INDIVIDUAL SEWER SYSTEM INSPECTION REPORT

Name of Owner Marilyn & David Bawn

Legal Address/Location 2965 Terrace Drive

SEWER PERMIT AND APPLICATION

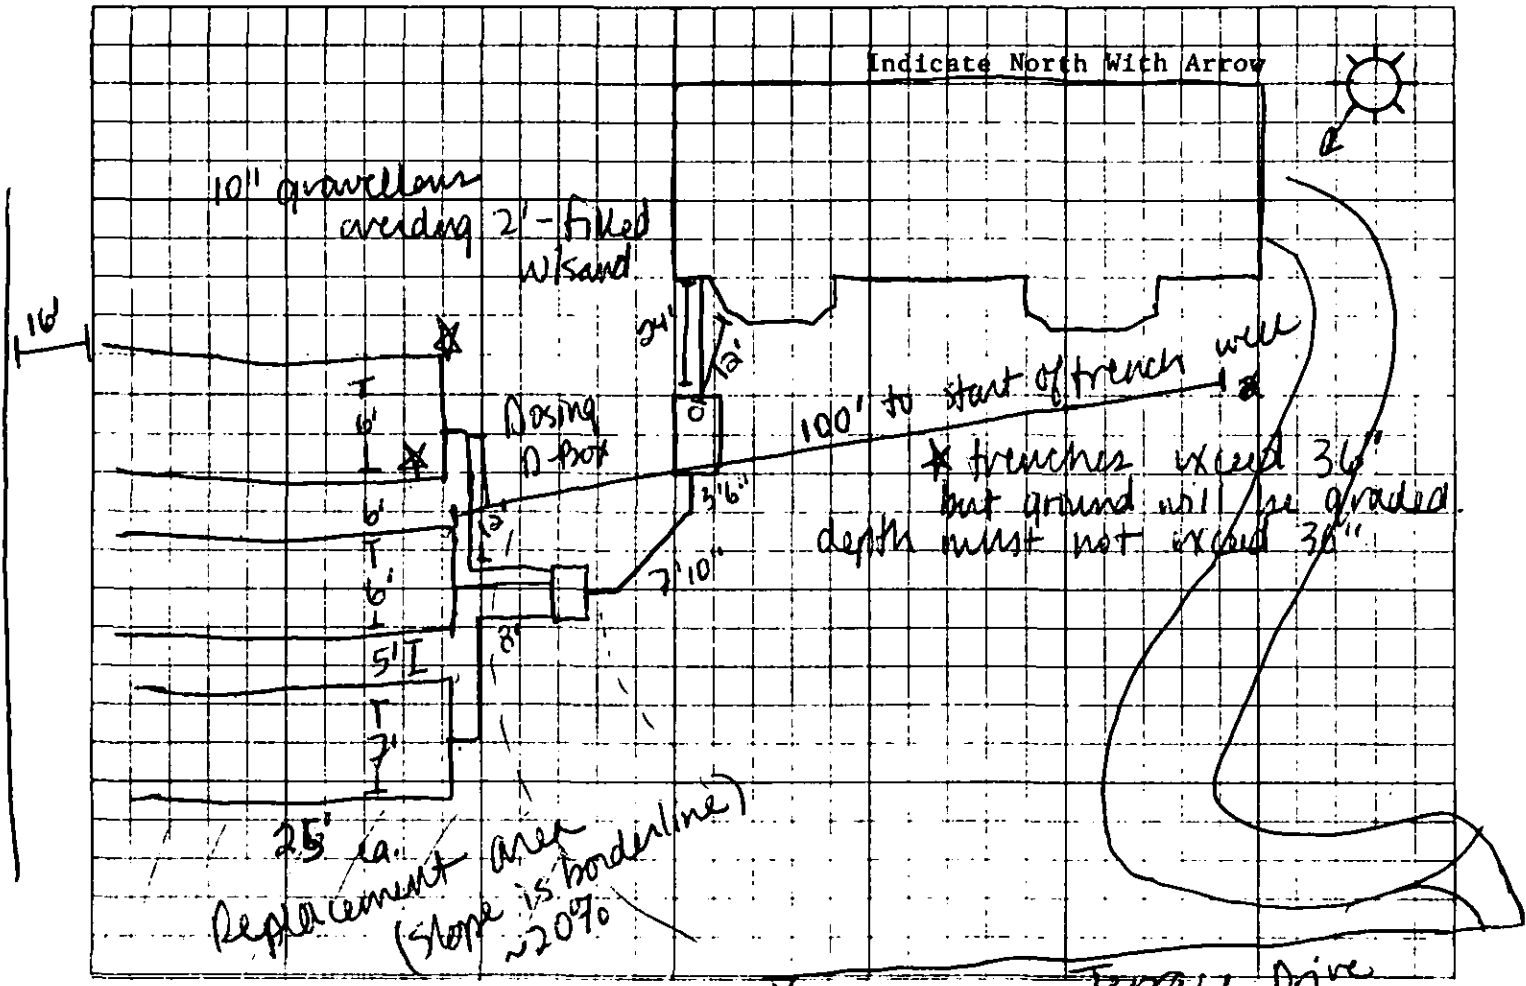
Corrections Necessary: X beel each header + check w/ level; grade final cover so that upper trenches don't exceed 36".
